DEVELOPMENT REVIEW BOARD

DEVELOPMENT REVIEW BOARD STAFF REPORT

Hearing Date: October 27, 2016	
Case No: DRB 2016-34	
Application(s): Minor Conventional Subdivision Final Plan	
Application Received: September 19, 2016	
Application Deemed Complete: September 21, 2016	
Staff Report Finalized: Friday, October 21, 2016	
Applicant(s): Connor and Meghann Rowley 501 Lake Road Milton, VT 05468 802-318-3544 connorowley13@aol.com	Owner(s): Rowley Family Real Estate c/o Lawrence Rowley 501 Lake Road Milton, VT 05468 802-893-7618
Engineer/License: Brian Tremback Lamoureux & Dickinson Consulting Engineers, Inc 14 Morse Drive Essex Junction, VT 05452	Surveyor/License: Doug Henson/#656 Lamoureux & Dickinson Consulting Engineers, Inc 14 Morse Drive Essex Junction, VT 05452
E-911/Postal Address: 17 Dixon Road	
Tax Map, Parcel(s): 14, 6	
School Parcel Account Number(s) (SPAN): 13077	
Deed(s): Book 333, Page 894	
Existing Size: 255.1	
Zoning District(s): Agricultural Rural Residential "R5"

Noticed Summary of Proposal: Rowley Family Real Estate II, LLC, Owner/Connor & Meghann Rowley, Applicants request Final Plan approval for a proposed 2-lot Minor Conventional Subdivision located at Lake Road and H

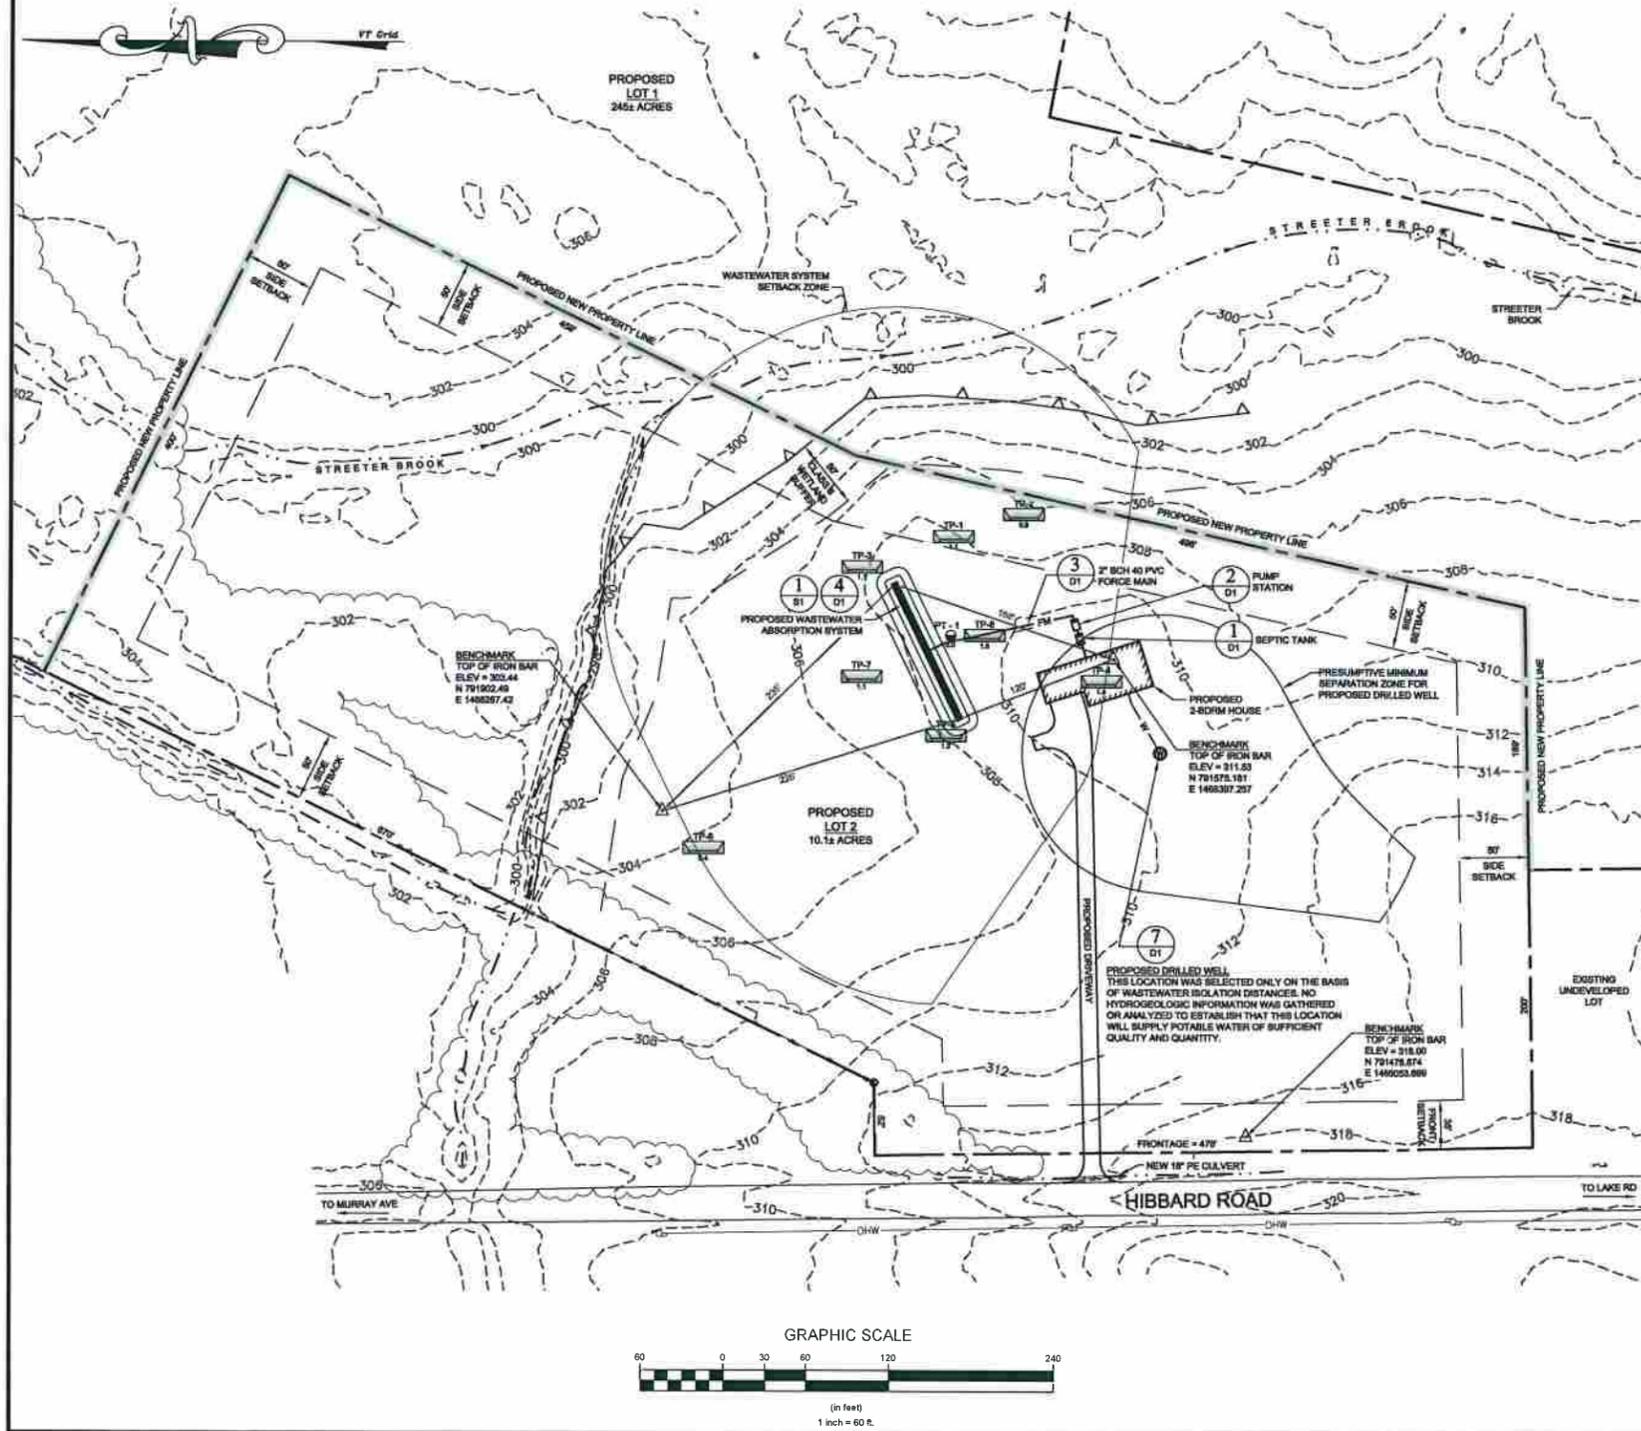
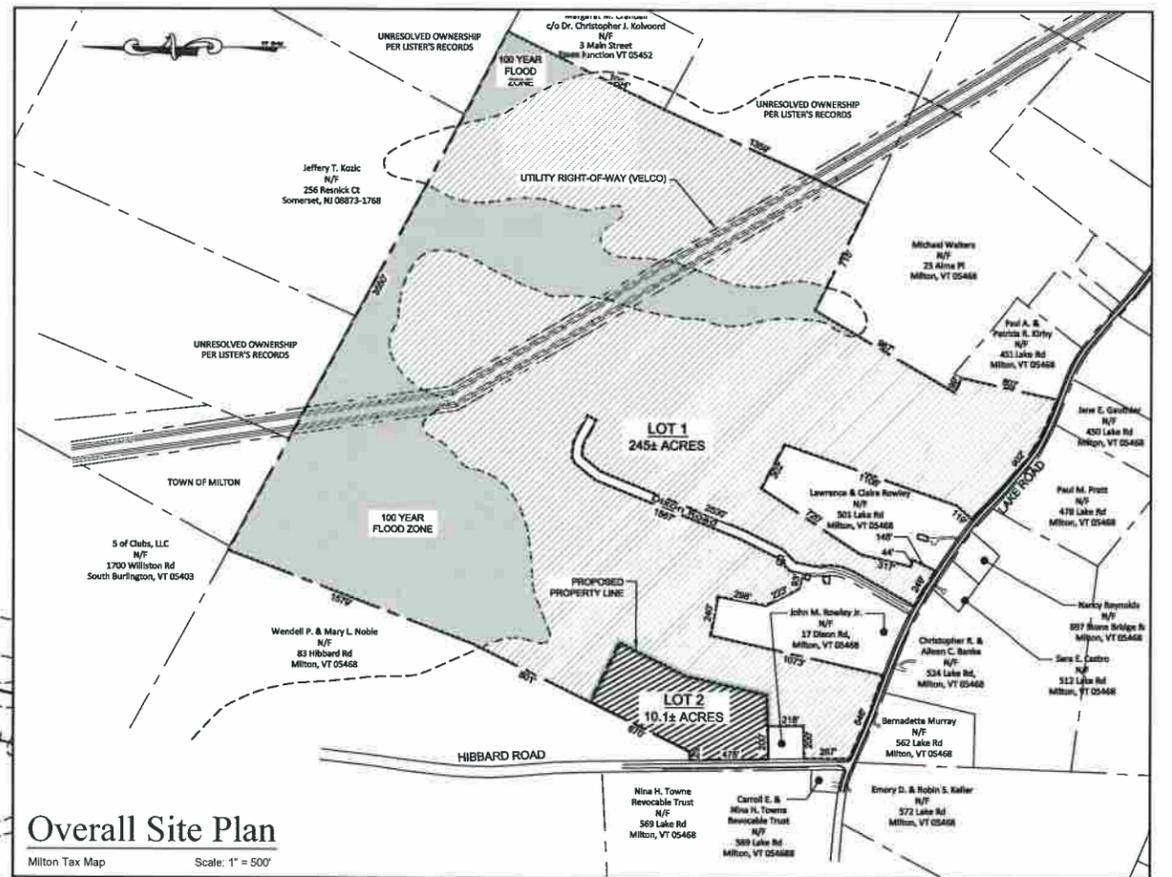
Staff finds that the existing house and barns do not meet the 35 foot minimum setback along Dixon Road. The proposal does not change this existing non-conformity. Lot 1 would conform to all other dimensional standards of the R5 District.

SR840, Drainage: The submitted site plan indicates the addition of a 18" culvert under the proposed driveway near the highway access with Hibbard Road. No other changes to the site drainage are proposed. According to SR840, "Where a subdivision is traversed by a water course or drainage way there shall be provided a storm water drainage easement of such width as to encompass the twenty five (25) year flood area of such water course, which easement shall be indicated on the Final Plat." The site is traversed by Streeter Brook.

SR850, Water System: The applicant has proposed an onsite drilled well for Lot 2. A state Wastewater System and Potable Water Supply Permit is required according to the submitted State Project Review Sheet.

SR860, Sewage Disposal: The applicant is proposing on-site sewage disposal with septic tank, pump station and absorption system. A state Wastewater System and Potable Water Supply Permit is required according to the submitted State Project Review Sheet.

SUBDIVISION SKETCH PLAN
LeCLAIRE TWO LOT SUBDIVISION
WESTFORD ROAD & FOREST ROAD
MILTON, VERMONT

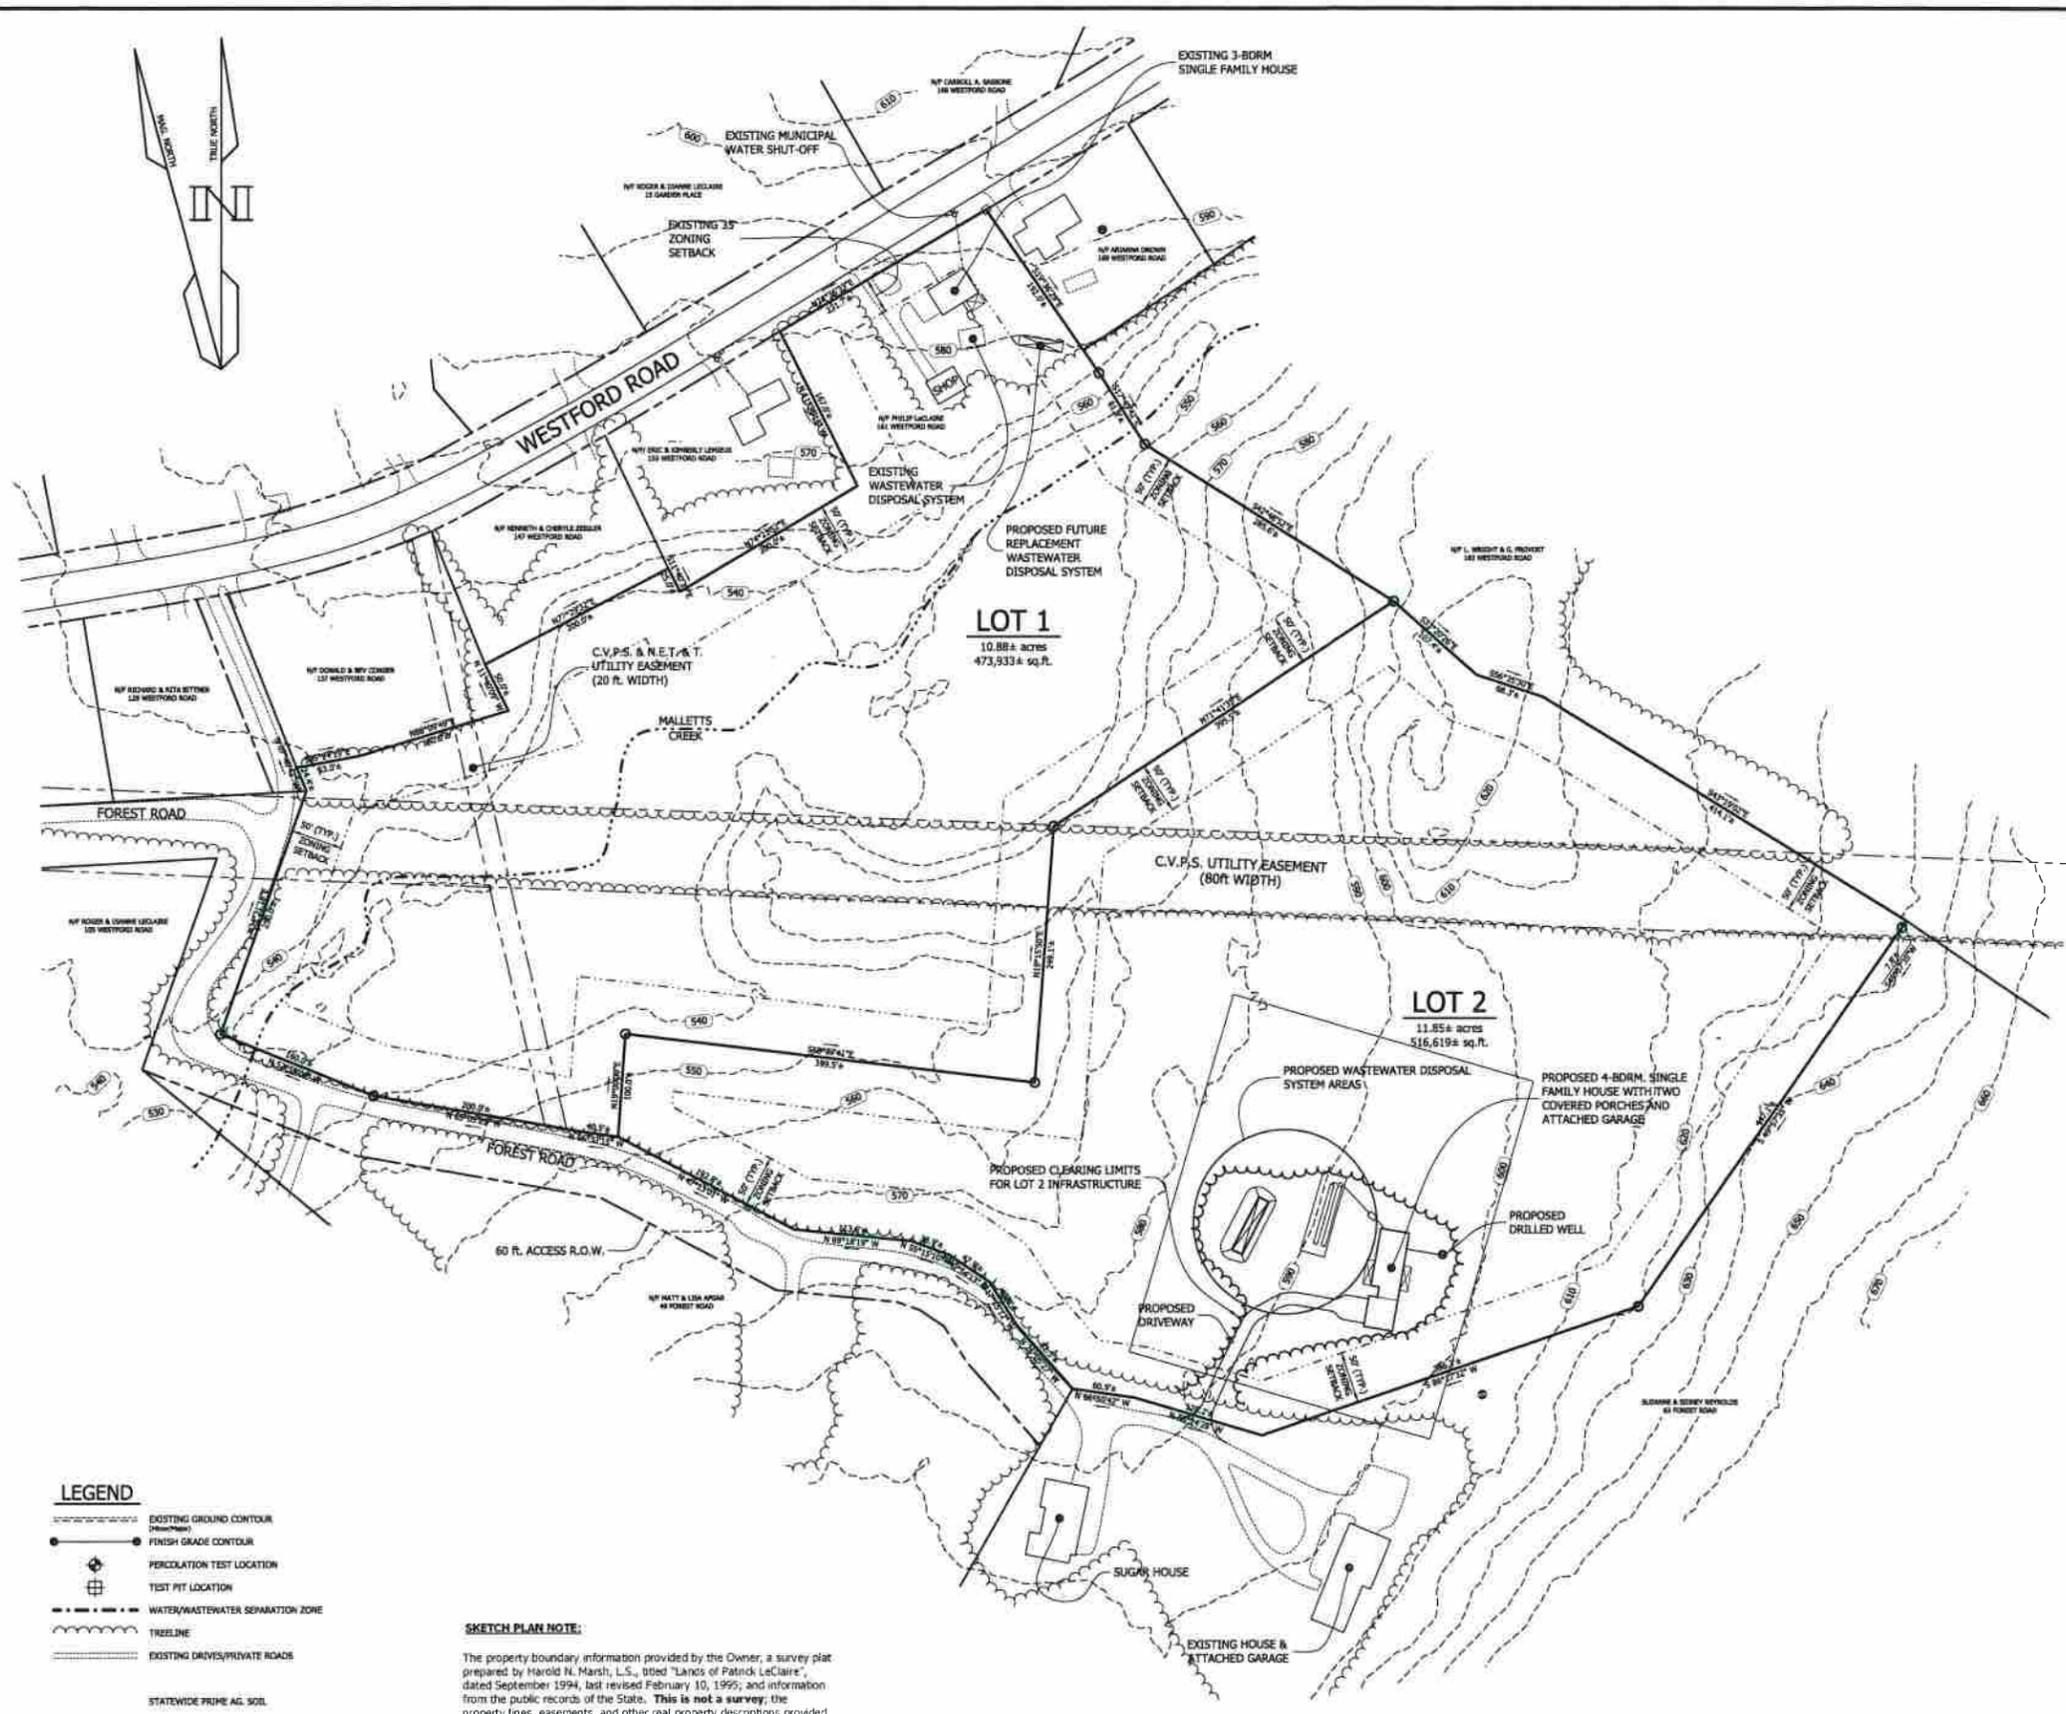
Topography & Drainage (Plan Map 5): The property drains toward Mallets Creek, which bisects the property, and flows to the west.

Streams and Shoreline (Plan Map 6): The property contains Mallets Creek, a mapped stream. The stream is indicated on the submitted plan. The applicant stated that no alteration to any stream course is proposed. The proposed buildings are at least 50 feet from Mallets Creek. No vegetative clearing or alteration is proposed within 25 feet of Mallets Creek.

Soil (Map 7): The applicant states that there are some statewide and prime agricultural soils present on the property and indicated on the sketch plan. Staff finds that the existing home is located within agricultural soils and no new disturbance is proposed that would impact agricultural soils.

SR840, Drainage: No change to drainage on the site has been proposed. This item will be further addressed pending Sketch Plan approval. According to SR840, “Where a subdivision is traversed by a water course or drainage way there shall be provided a storm water drainage easement of such width as to encompass the twenty five (25) year flood area of such water course, which easement shall be indicated on the Final Plat.”
